DESIGN REVIEW COMMITTEE

700 Doug Davis Drive
Hapeville, GA 30354

May 17, 2023 6:00 PM

AGENDA

3 BACK EXTERIOR ELEVATION
SCALE: 1/4" = 1'-0"

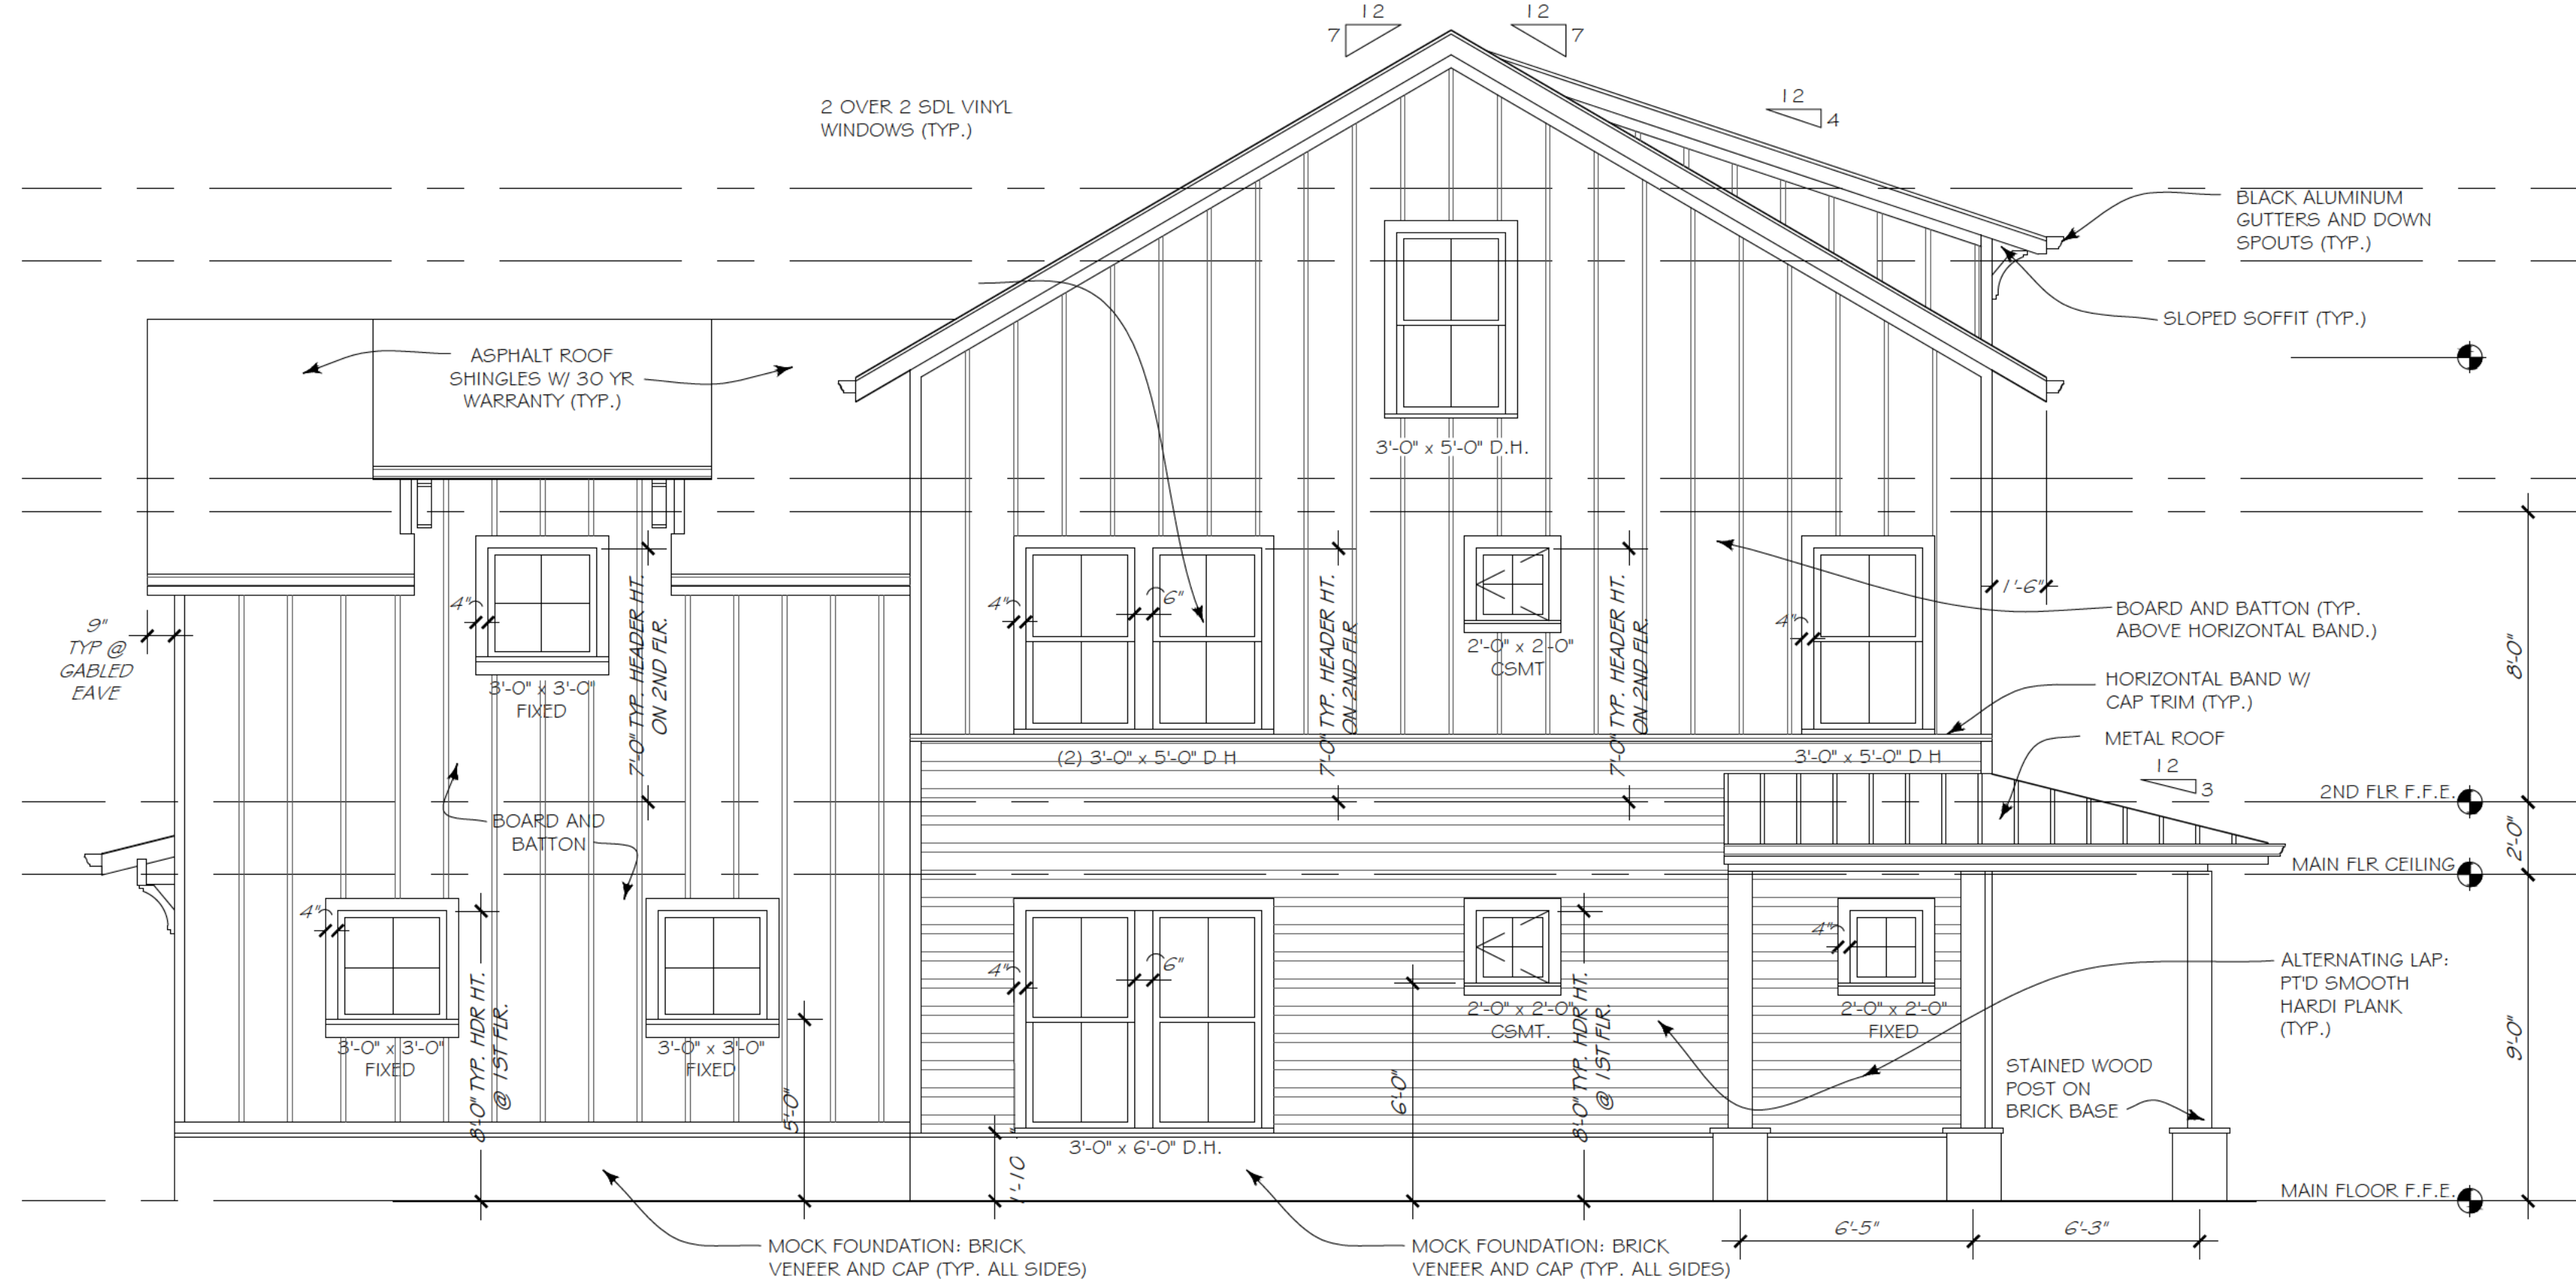
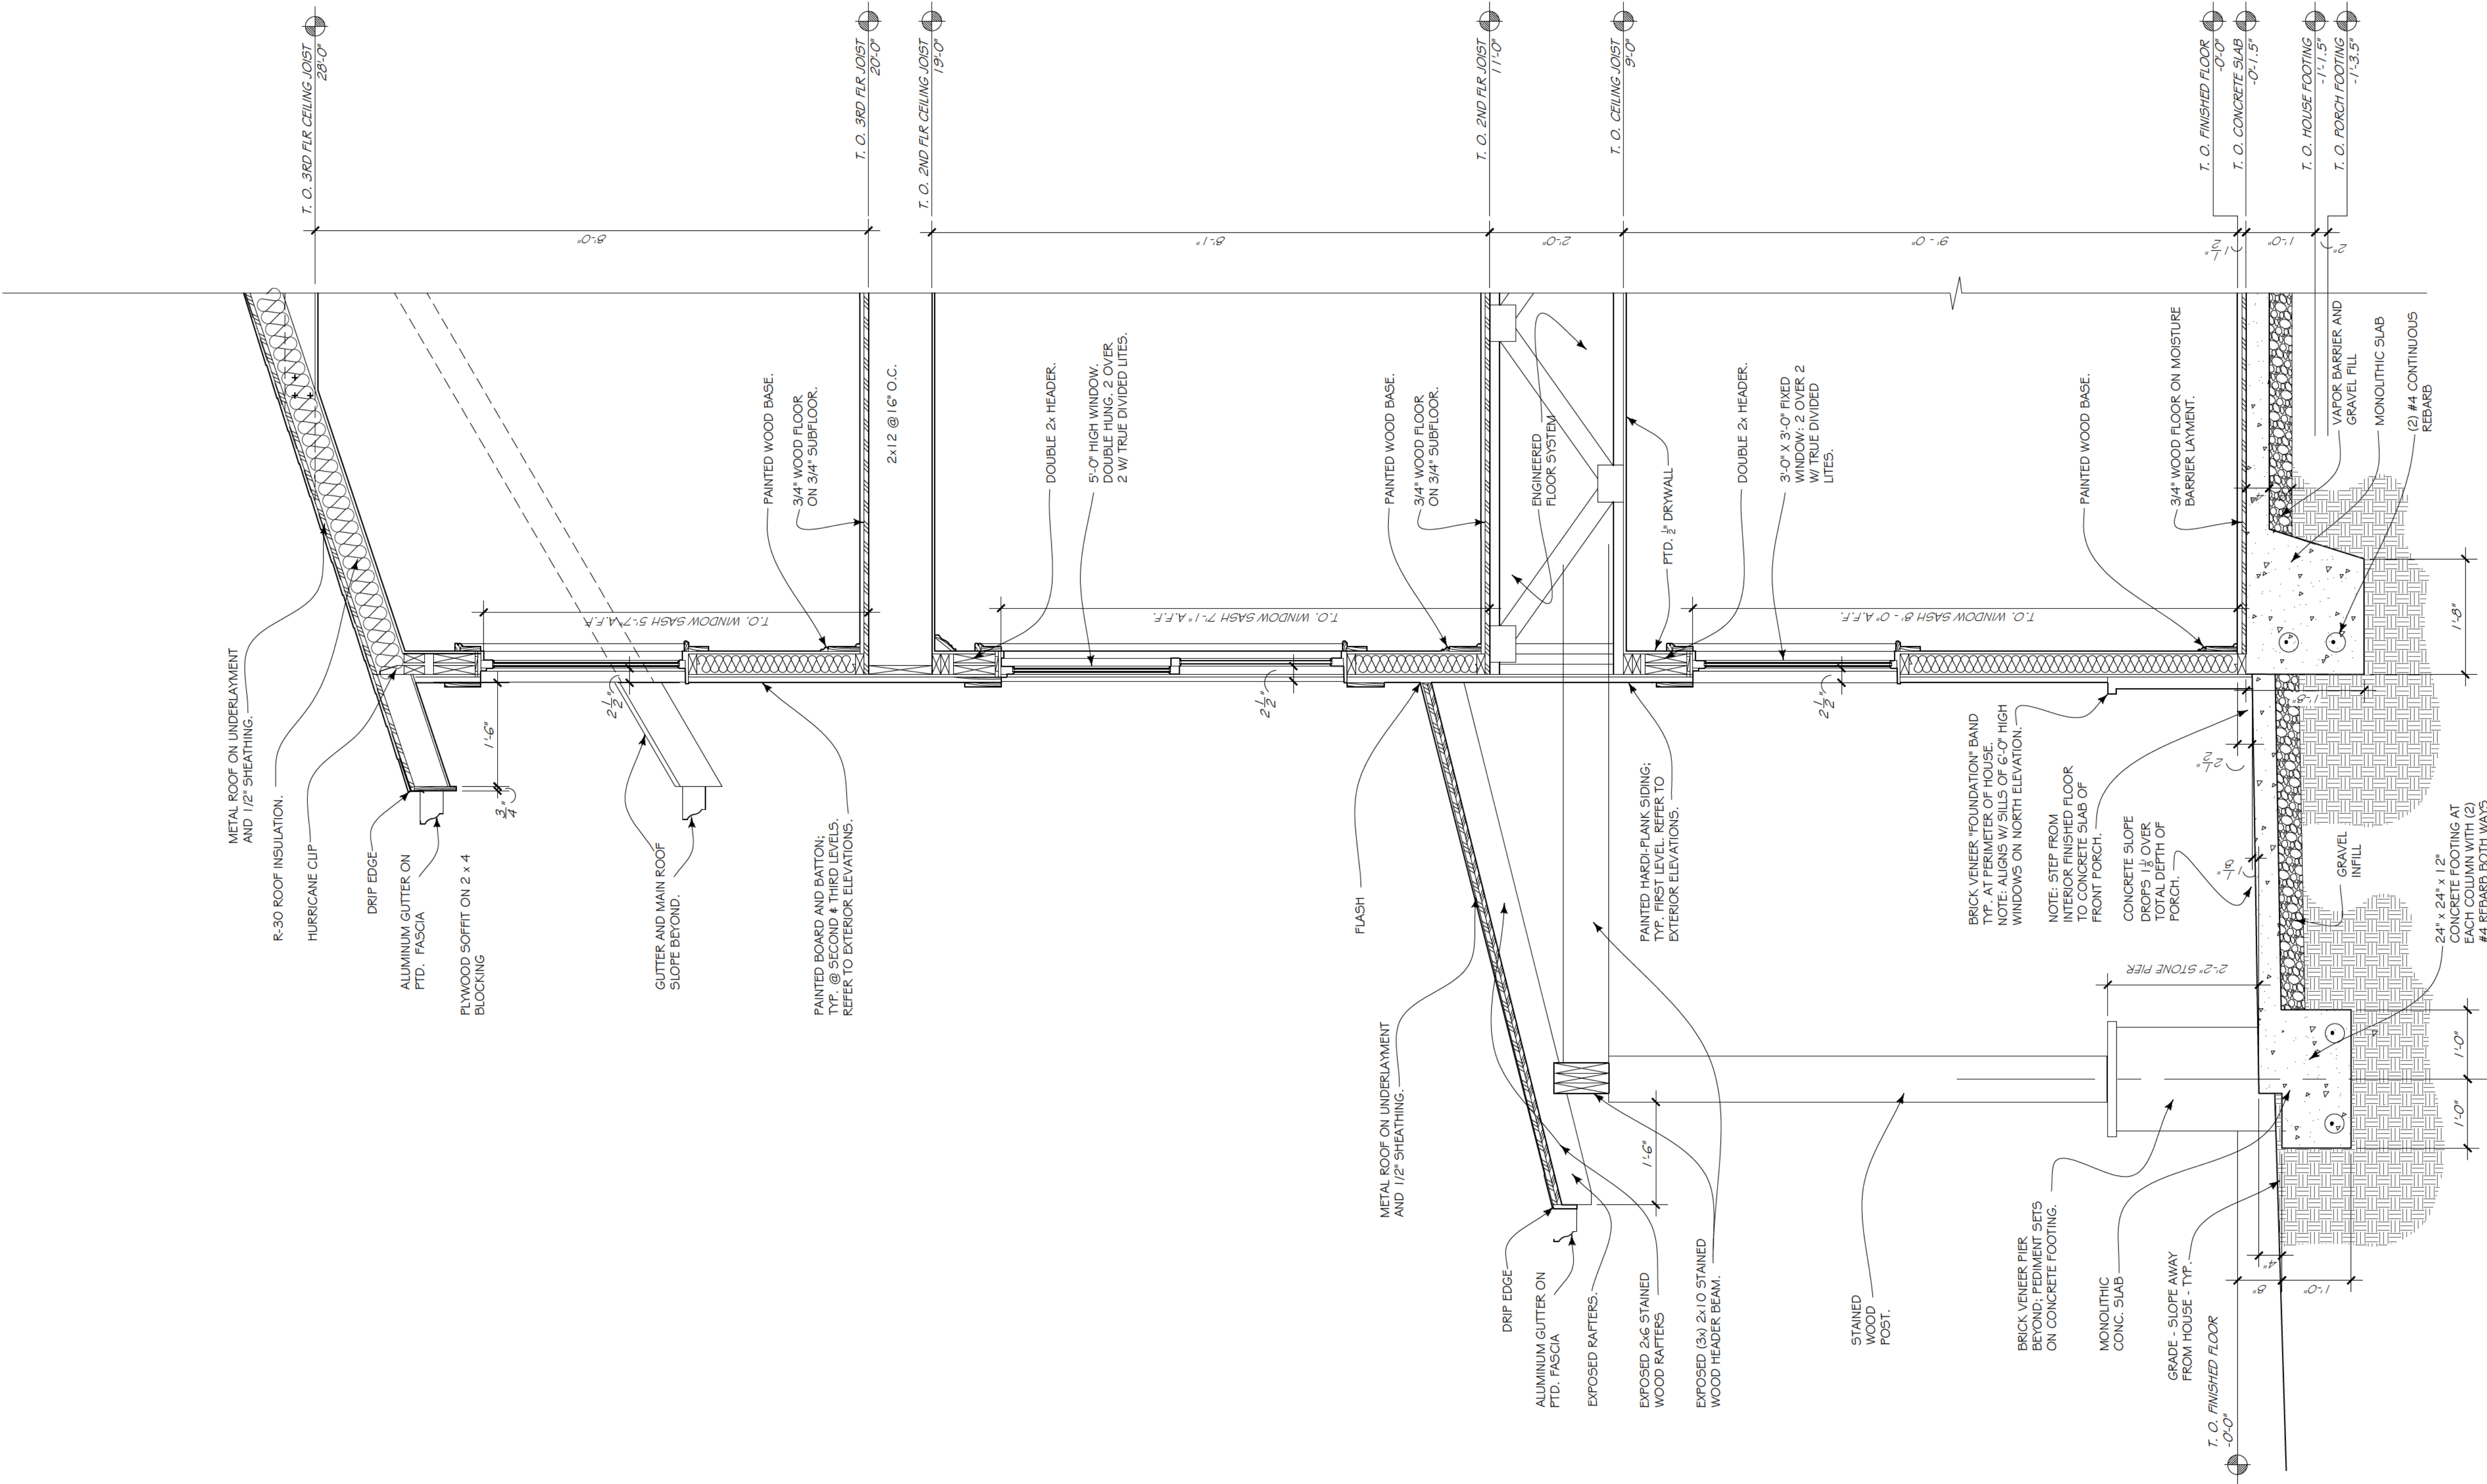
STAFF COMMENT: Windowless wall on 1st floor of side elevation. Stairs, kitchen and garage located on first floor. Design Exception Requested.

STAFF COMMENT: 2nd floor windows are approximately 21%.

- Updated site plan showing dwelling outside of the 15' setback.
- 2nd story windows are 21% of façade.
- Provide sill height
- Approved Tree Conservation Plan (submitted and under review by Arborist)

PROPOSED FLOOR PLAN - LOWER LEVEL The new deck will not be added

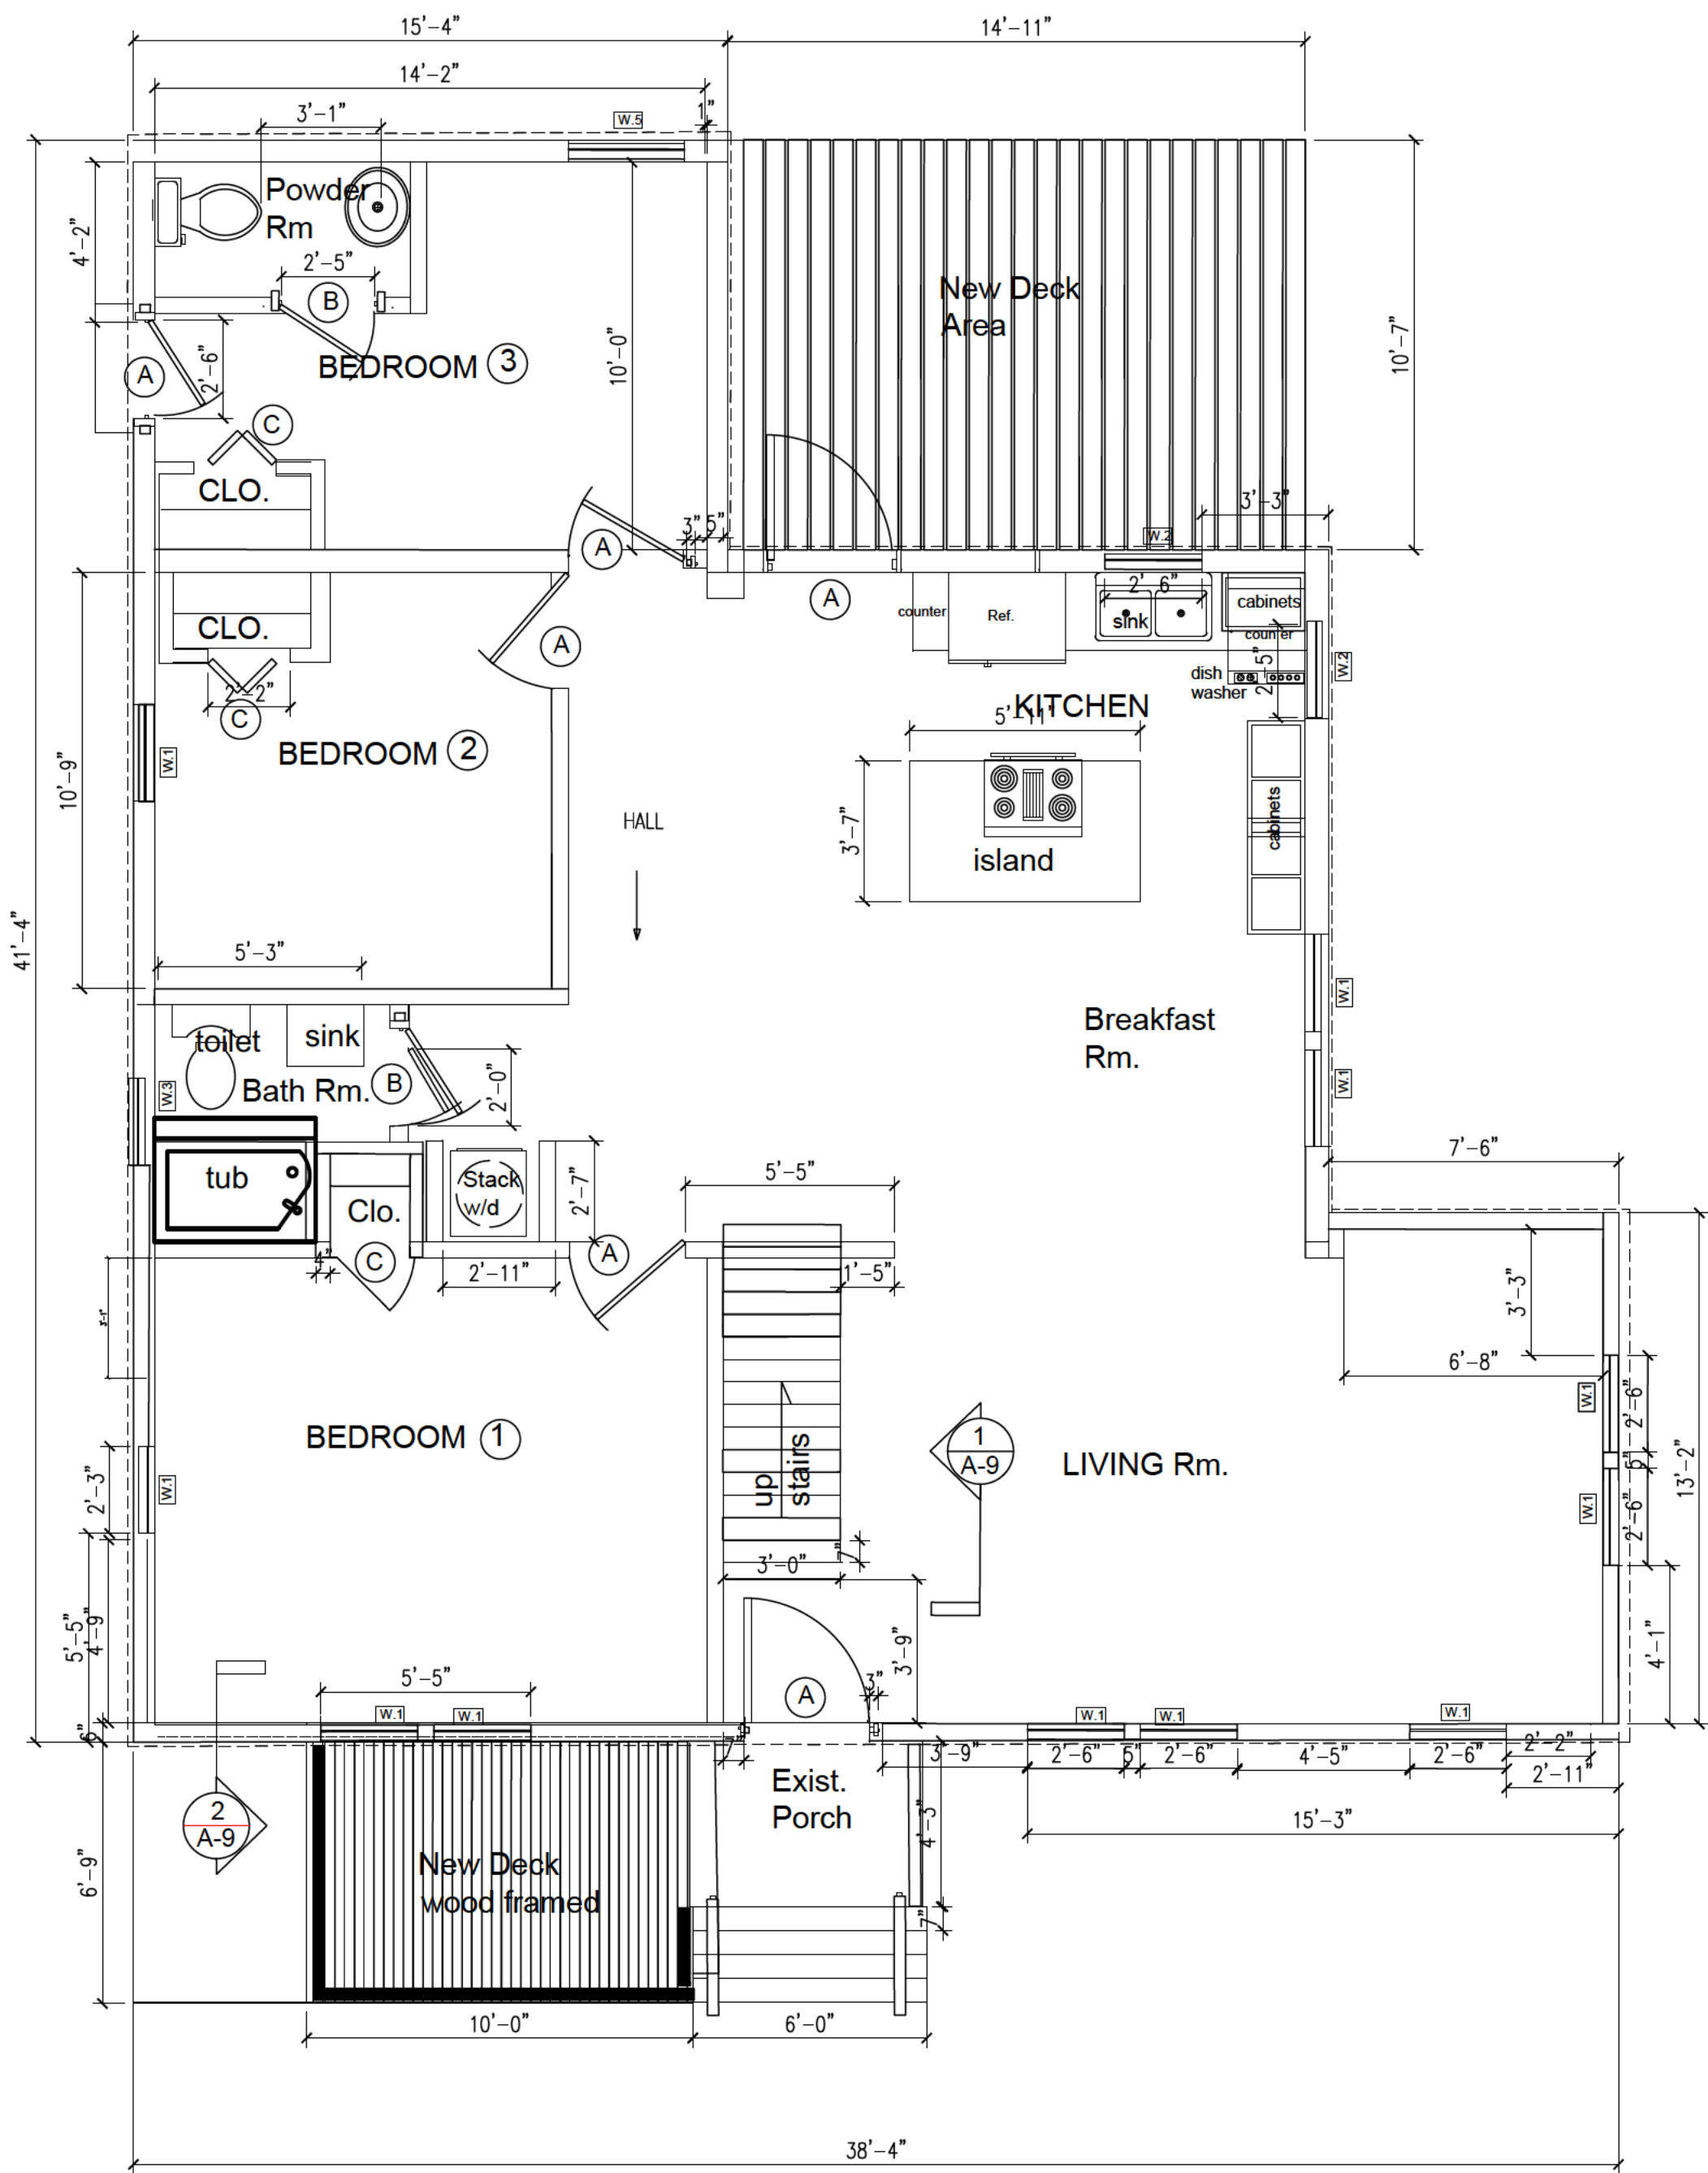
- Ensure that windows are not GBG. Only second floor windows in front are called out this way.
- Note: please have the front deck removed from the drawings. This is not approved.
- Correct Sheet 1 that references the overhang as 1/2" not 12".
